**Amendment-II**

Ref.: Tender No. HSCC/SJH/Med.Eqpt./2016/22 dt. 10.10.2016.

Sub.: Procurement of Medical Equipment for New Emergency Block & Super-Specialty Block at Safderjung Hospital, New Delhi.

### **Site Layout Plan**

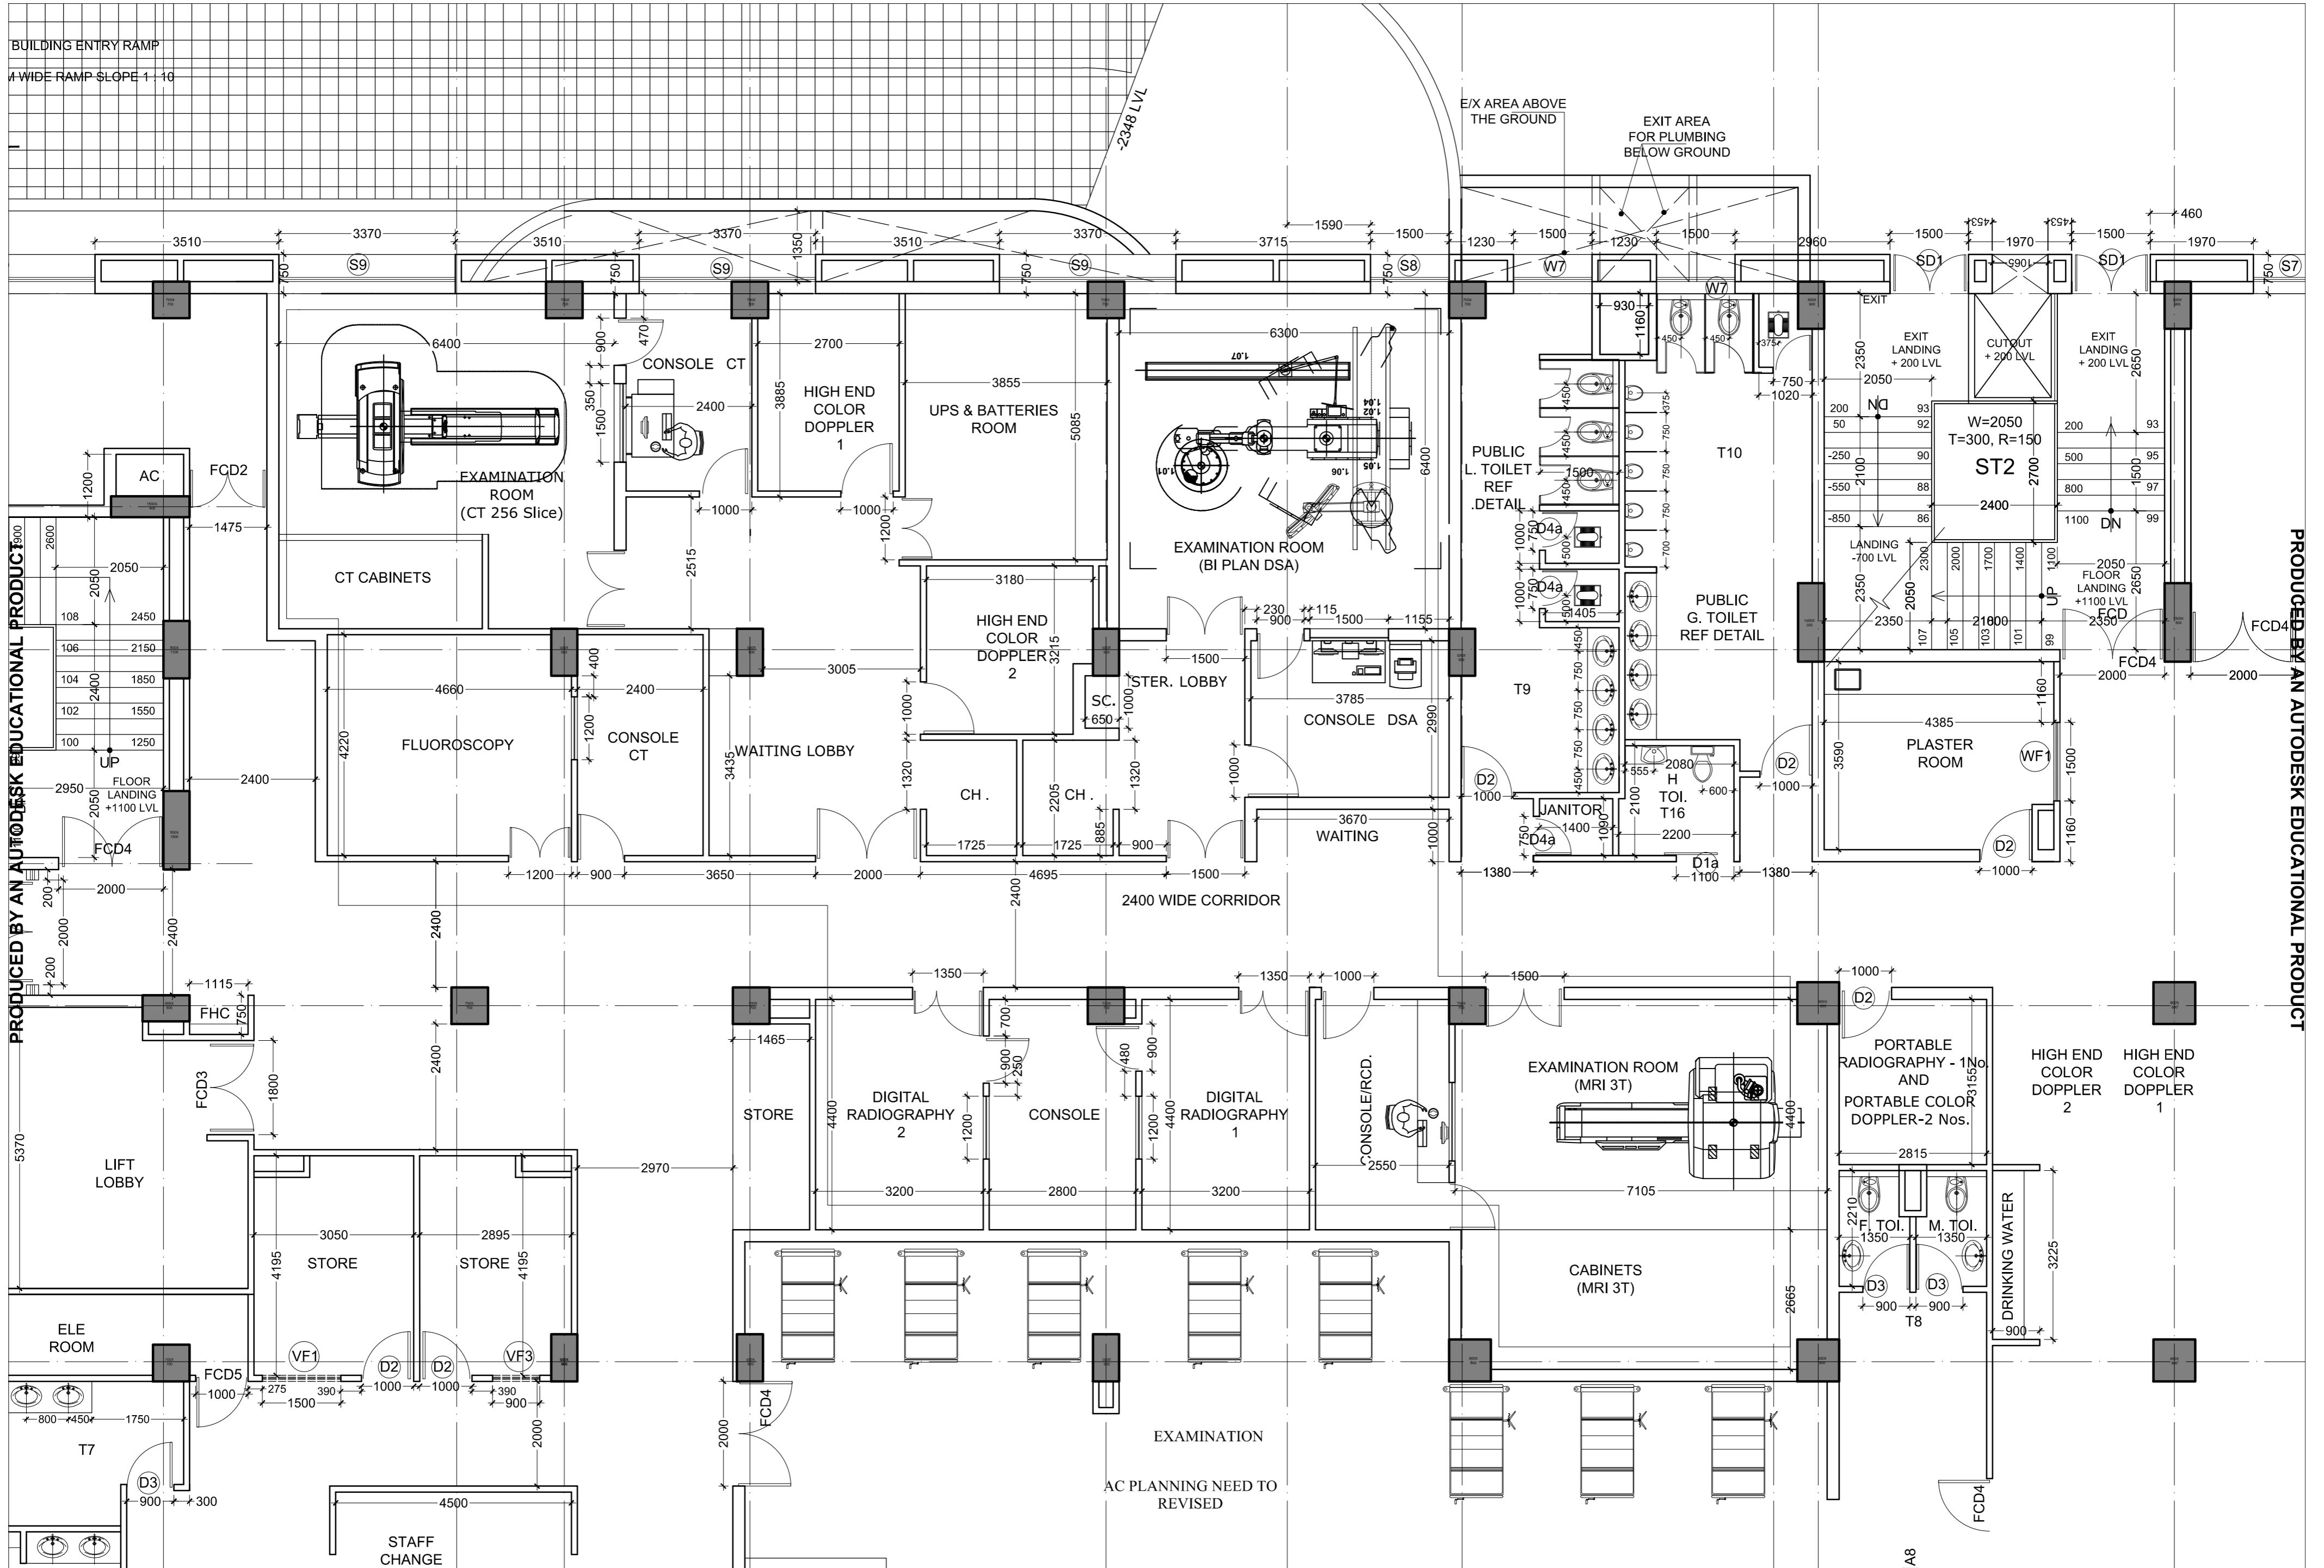
EXAMINATION  
AC PLANNING NEED TO REVISED
